**Applicant's comments on Deadline 3 Submissions**

**PINS Reference Number: EN010069**

**Deadline 4 – 1 February 2019**

Figure 1 Temperature Inversion and Technology Differences

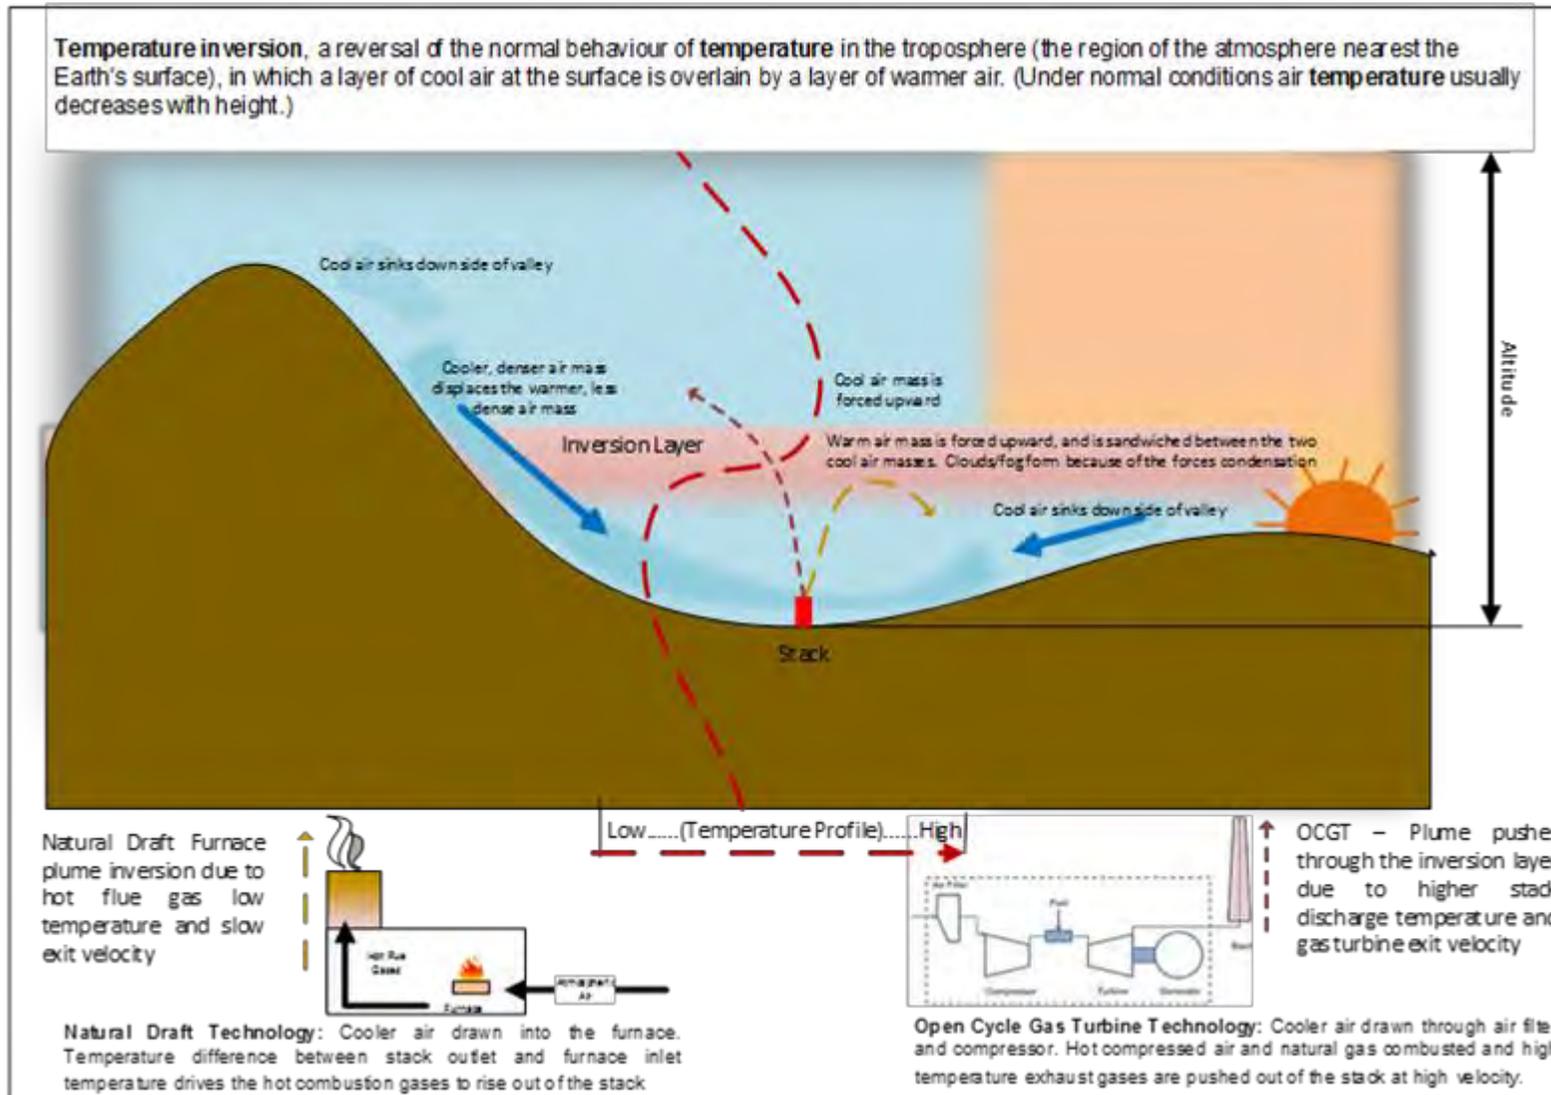
- 3.1.1 The respondents have raised concerns regarding terrain effects/temperature inversions, and the effect that this will have upon the dispersion of emissions from the stack of the Abergelli Power Project. The representation is accompanied by photographs.
- 3.1.2 The respondents have also proposed that a risk assessment should be carried out by an independent meteorologist.

- 3.1.5 The Applicant notes that there is only limited information about the old Felindre Tin Plate Works, which the respondents reference. Given the age and the type of the former works it is assumed that it burned coal, charcoal or wood which would give rise to larger concentrations of particulate matter and water, along with NO<sub>2</sub>, CO<sub>2</sub>, CO and SO<sub>2</sub>, in the Tin Plate Works stack emissions in comparison to the Project. Furthermore, the technology of the Tin Plate Works differs greatly from the proposed development (i.e. stack was designed to function with natural draft ventilation of the furnaces with lower exit velocities e.g. 10 metre per second). In consequence the naturally drafted stacks of the Tin Plate Works have much less movement of air mass and have reduced capacity to penetrate the inversion layer. The Applicant concludes that this is not a representative technology comparison, as the high exit velocities and high exit temperatures of Open Cycle Gas Turbine technology that is proposed are beneficial for plume rise and penetration of the inversion. See Figure 1 for information.

- 3.1.11 While there is only limited information about the old Felindre Tin Plate Works, which the respondents reference, given the age and the type of works we assume that it burned coal and possibly charcoal and/or wood and that the stack was designed to function with natural draft ventilation of the furnaces i.e. to aid in drawing cooler air into the furnace to force the hot combustion gases to rise out of the stack. In naturally drafted stacks, the exit velocity is determined by the temperature difference between the exhaust gas in the stack and the temperature of the outside air which affects the air density and hence movement of air. Naturally drafted stacks typically have exit velocities of less than 10 metres per second (m/s) which is relatively low and so the exhaust gases have reduced capacity to penetrate the inversion. High exit velocities and high exit temperatures are beneficial for plume rise and penetration of the inversion.

- 3.1.12 In comparison, the proposed OCGT plant stack has been specifically designed to maximise dispersion through high exit velocity and temperature of the exhaust gases. The proposed OCGT will have an emission temperature of 590°C and is a forced draft rather than naturally drafted system, i.e. the exhaust gases exit the stack at a higher velocity than would occur due to the difference in stack gas vs ambient air temperature, with the proposed stack having an emission velocity of 45 m/s (101 miles per hour), significantly higher than can be achieved by a naturally ventilated system and much higher than would be achieved by a fan assisted stack.
